ATTACHMENT 3

PROPOSED TECHNICAL SPECIFICATIONS

Marked up Technical Specification Pages;

FIGURE 2.1-1
REACTOR CORE SAFETY LIMIT - THREE LOOPS IN OPERATION

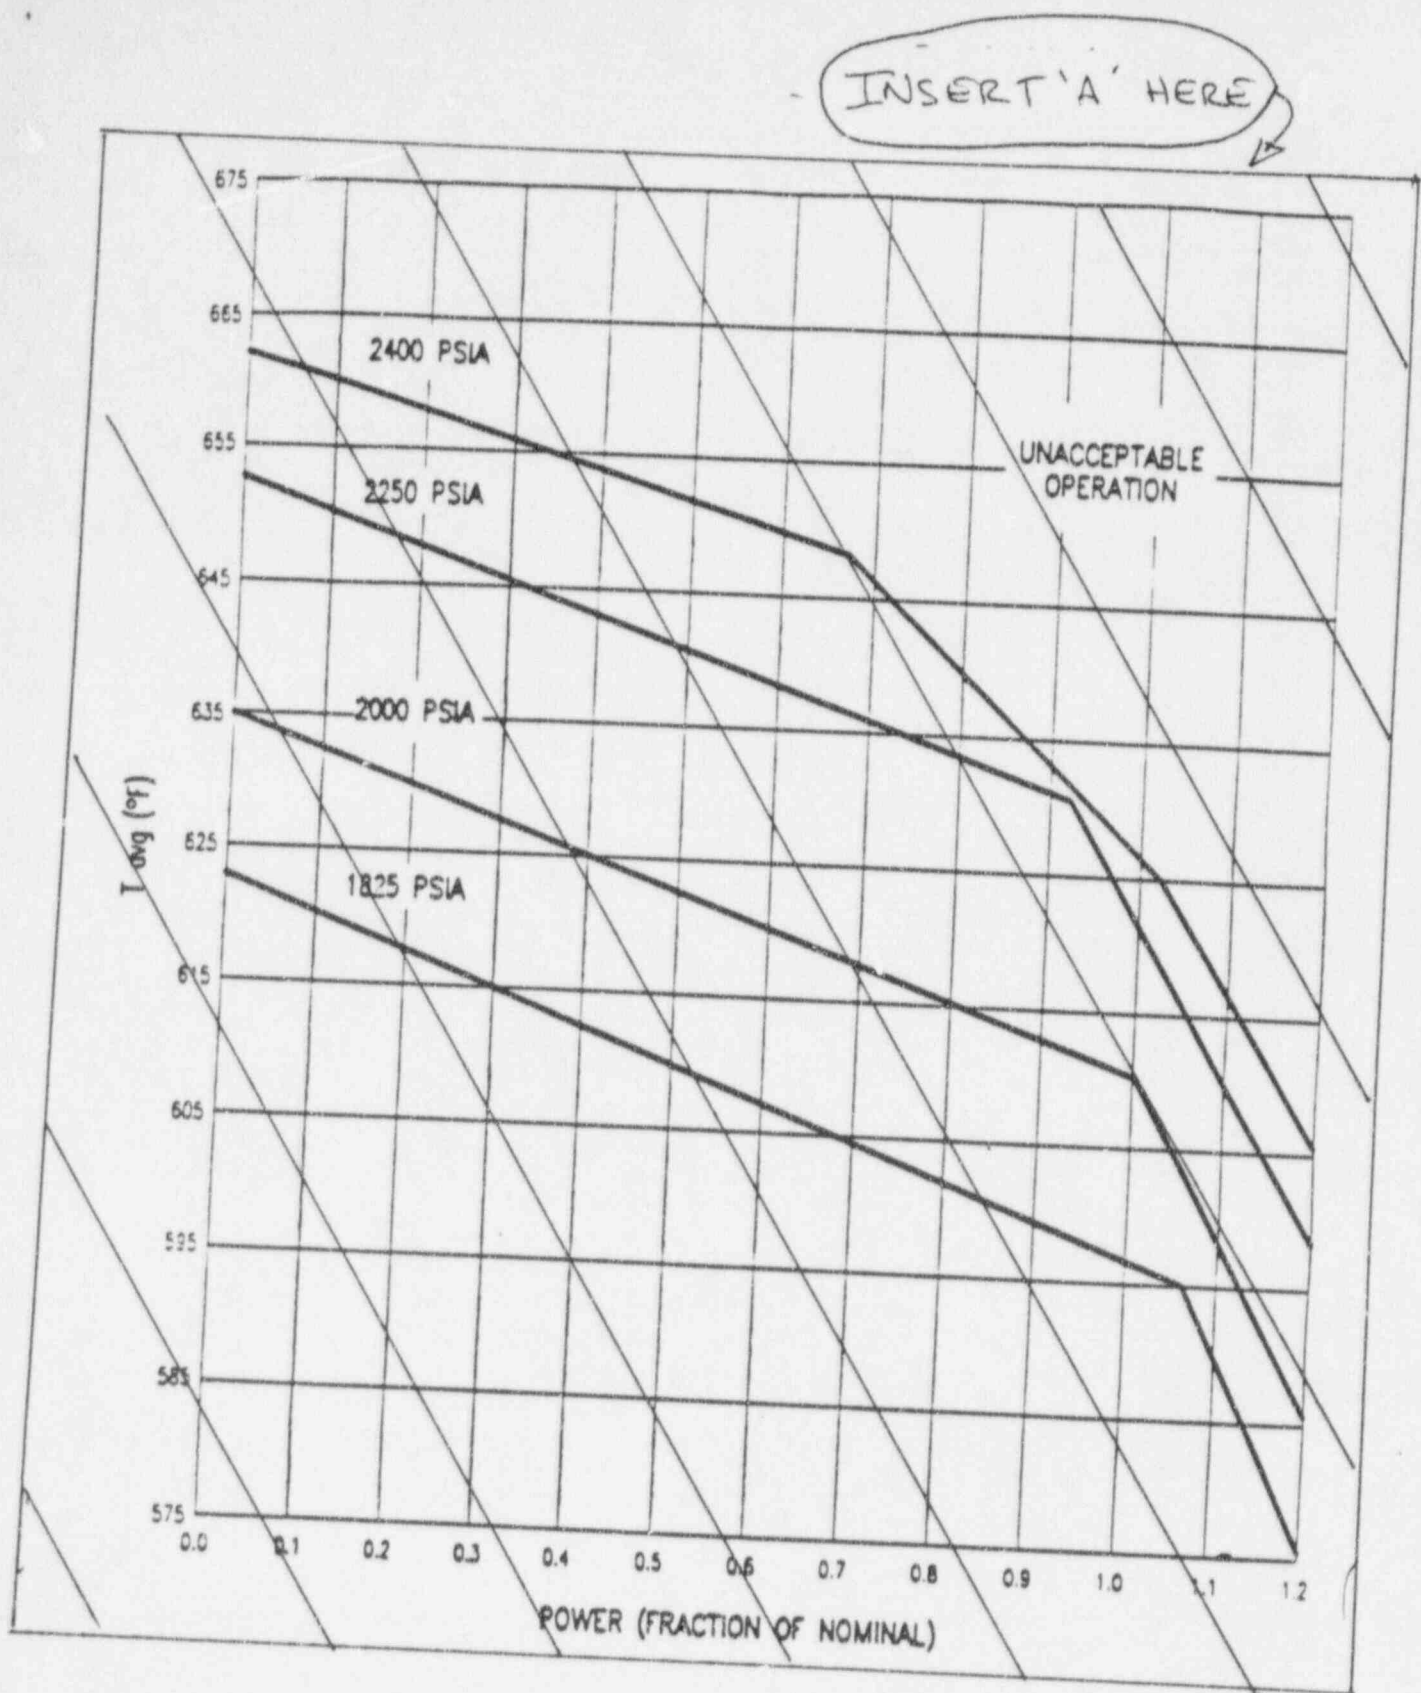
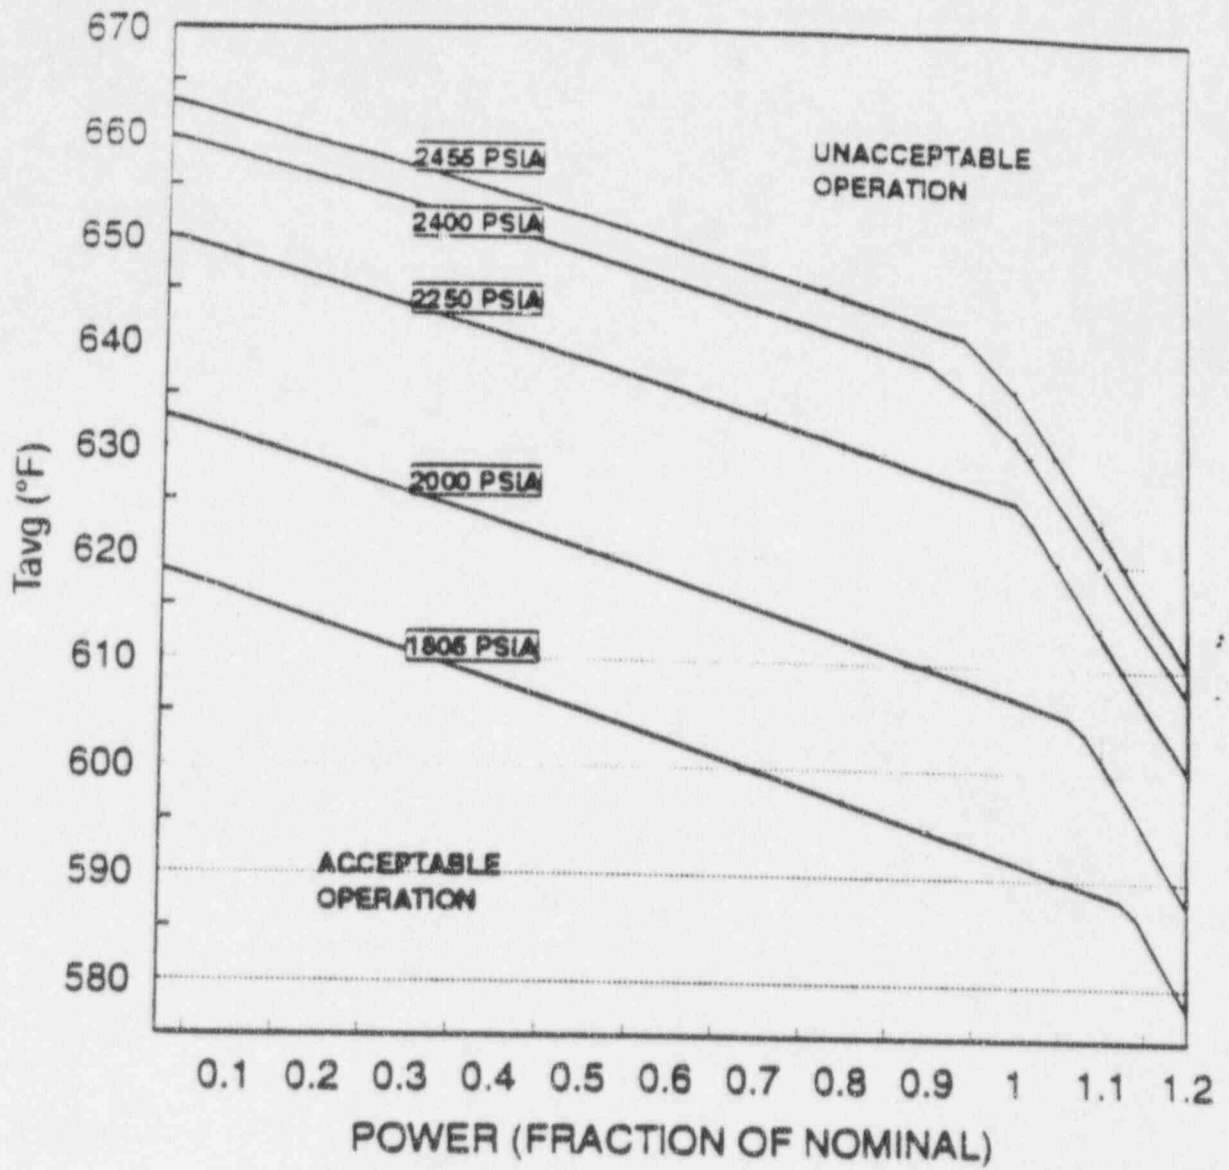
INSERT A

Figure 2.1-1
Reactor Core Safety Limit - Three Loops in Operation
